Review of NIOSH Strategy for Reconstructing Doses to Workers at Test Area North (TAN)

**John Mauro and Amy Meldrum
S. Cohen and Associates**

**Advisory Board on Radiation and Worker Health/ABRWH
Center For Disease Control and Prevention**

November 10, 2015

External Dosimetry – Sub-Areas of TAN

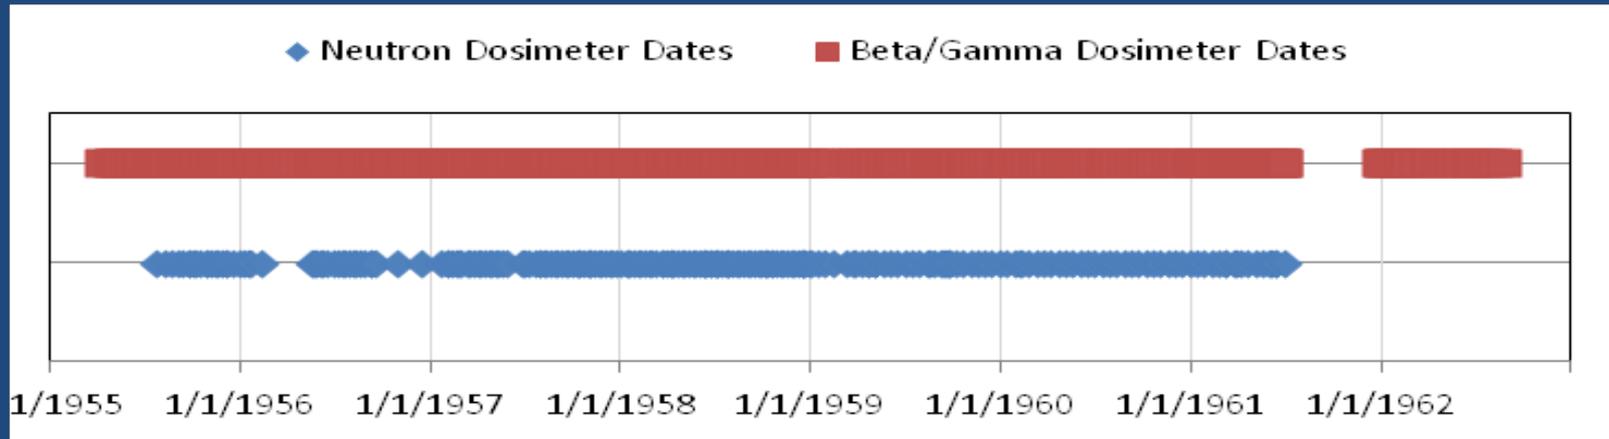
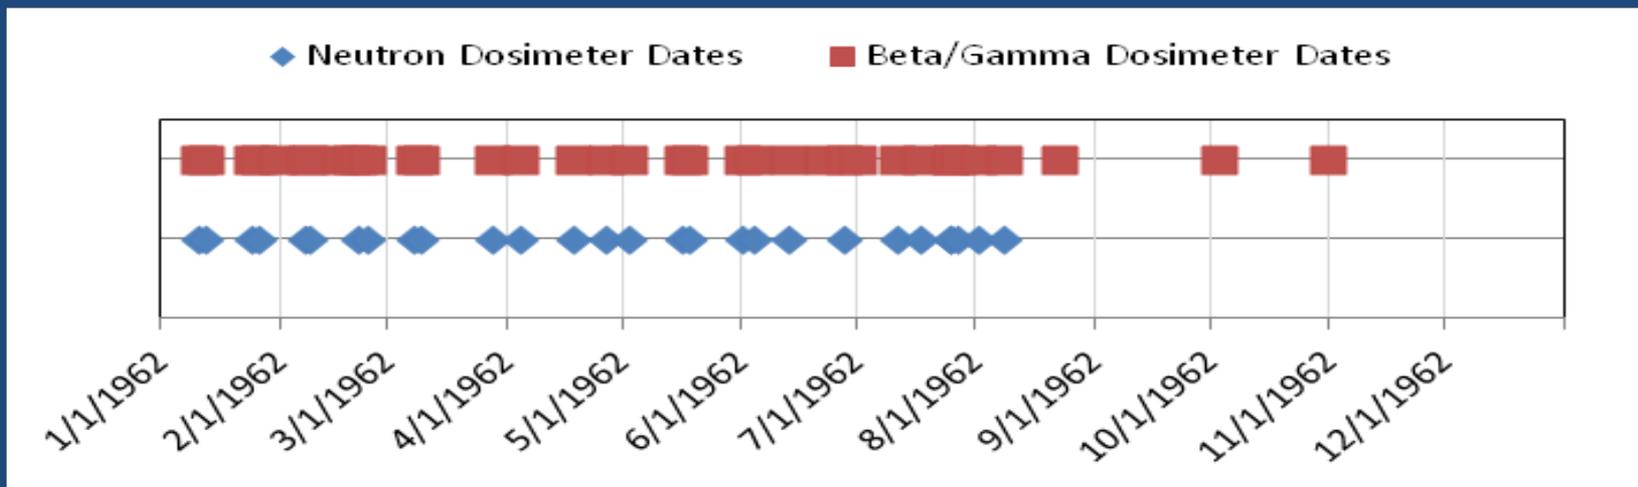
- Dosimeters Marked 'ANP'

- Dosimeters Marked 'STPF'

- External dosimetry for TAN as a whole appears to be fairly complete from mid-1955 through part of 1970, with a small gap from June through December 1961
- It is not possible to group the data by subdivisions of TAN; i.e., the data lack adequate granularity
 - Important because activities and research throughout TAN were extremely diverse. It will be difficult to build external dosimetry co-worker models for each subdivision of TAN.
- Neutron dosimetry data appears spotty. The possible reasons for this require further investigation
 - May need additional data capture

External Dosimetry – Sub-Areas of TAN

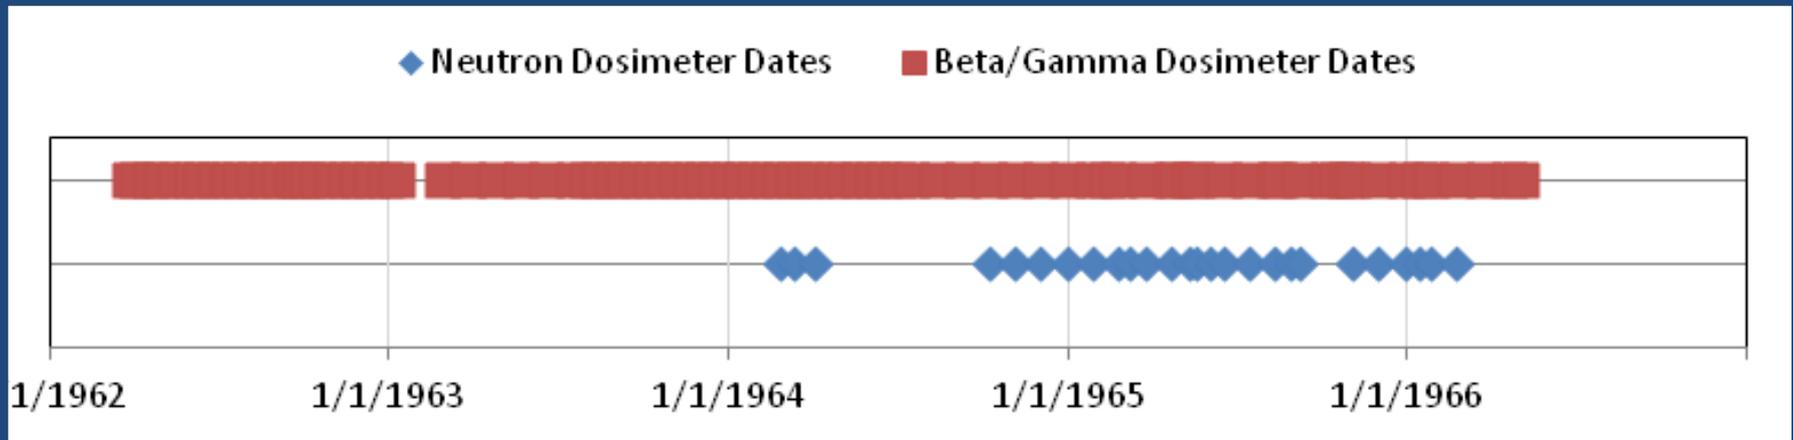
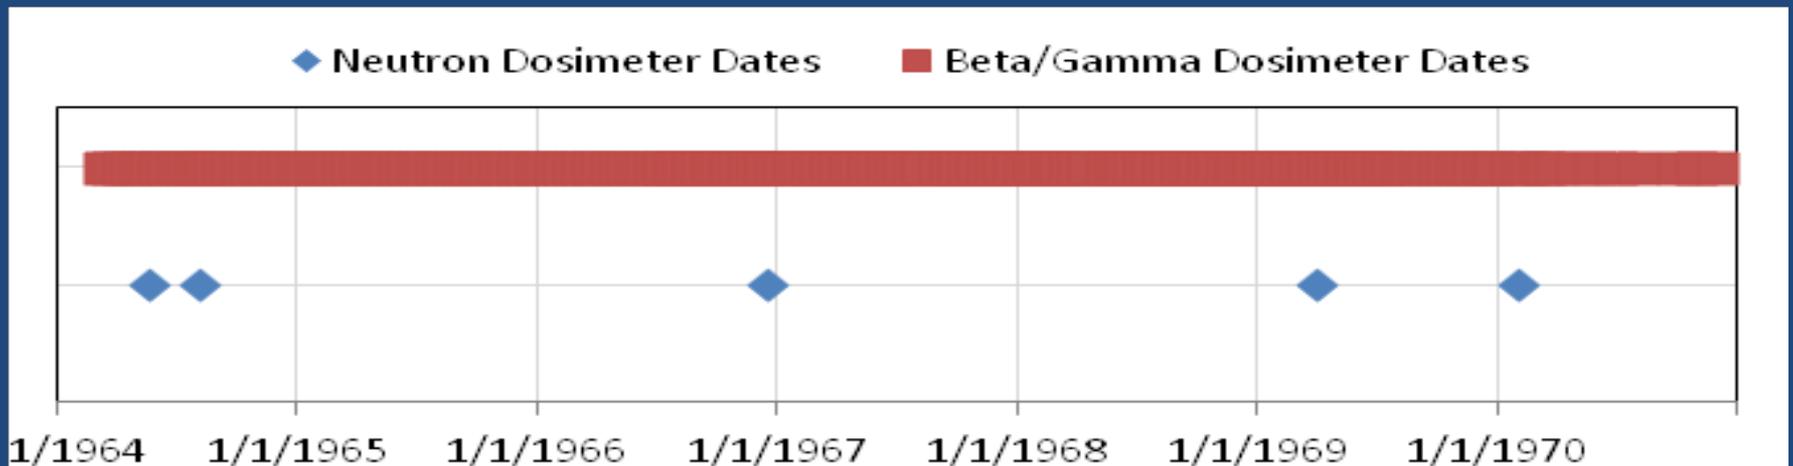
- Dosimeters Marked 'IET or STEP' (Both seen with code 68)

- Dosimeters Marked 'TSF'
